**Subj: Responses to Comments for the Fallbrook Point Project, located at  
22815-22825 West Roscoe Boulevard (Case Number ENV-2021-10328-MND)**

## **Mitigated Negative Declaration (MND) for the Proposed Fallbrook Point Project (ENV-2021-10328) (Proposed Project)**

## **COMMENT LETTER A – South Coast Air Quality Management District (May 12, 2022)**

**Figure 2**      *Excerpt from L.A. CEQA Thresholds Guide, p. I.1-3*

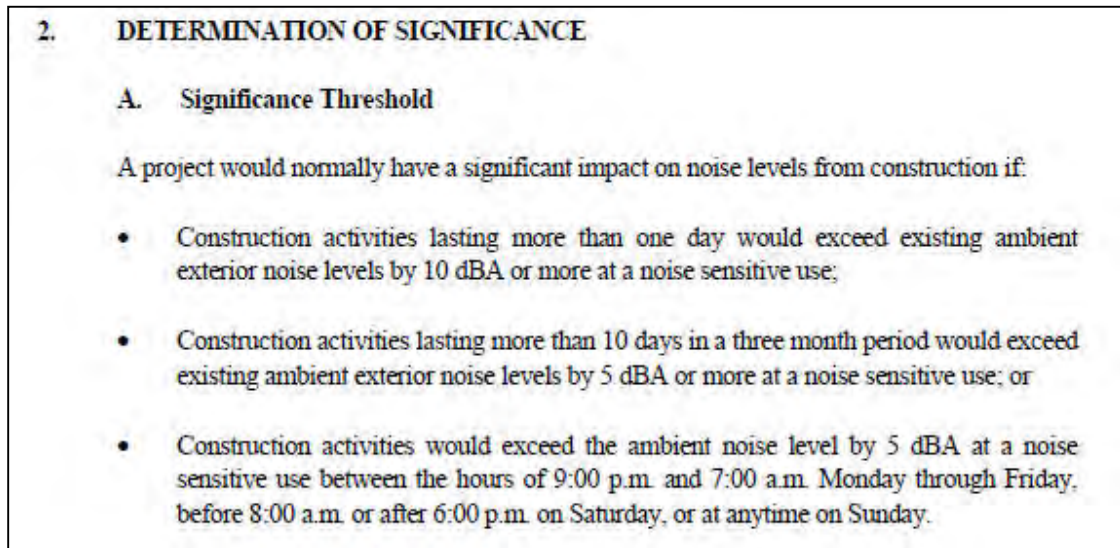
Because the project will have a duration of several months (final quarter of 2022 and completion in 2023, page 14), the second bullet point provides the applicable standard: construction noise that exceeds the existing ambient exterior noise levels by 5 dBA or more at a noise-sensitive land use constitutes a significant noise impact. Assuming that the measurements taken on the project property (M1, M2, and M3) are representative of the RECEIVING land use on the other side of the road (Figure XIII-1), then the significance thresholds would be 65 dBA, 63 dBA, and 71 dBA (Leq.1hr), respectively.

**Figure 3** Excerpt from L.A. CEQA Thresholds Guide, p. I.2-3

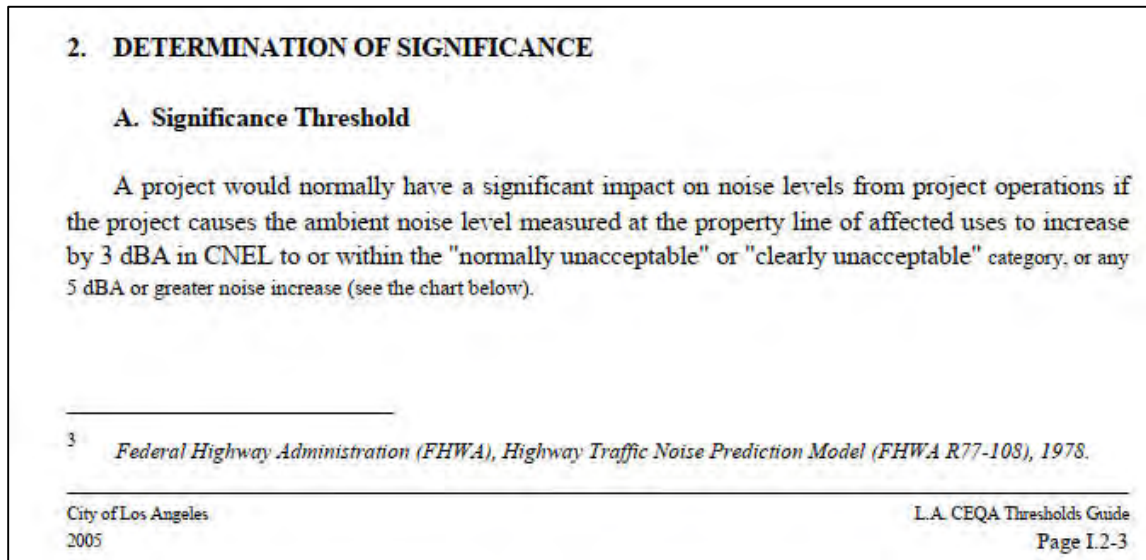
Similarly, LACEQA identifies significance thresholds for operational noise as shown in Figure 3. The LACEQA criteria reference the land use compatibility chart from the California Department of Health services in terms of CNEL. The ISMND lacks evidence that documents the baseline CNEL, as discussed above. Thus, the significance threshold for operational noise cannot be determined based on the information provided in the ISMND. The ISMND uses 5 dBA noise threshold for daytime operations to determine compliance with the LAMC, but this may not be adequate, pending confirmation of the existing nighttime ambient, CNEL and land use compatibility, per Figure 3.
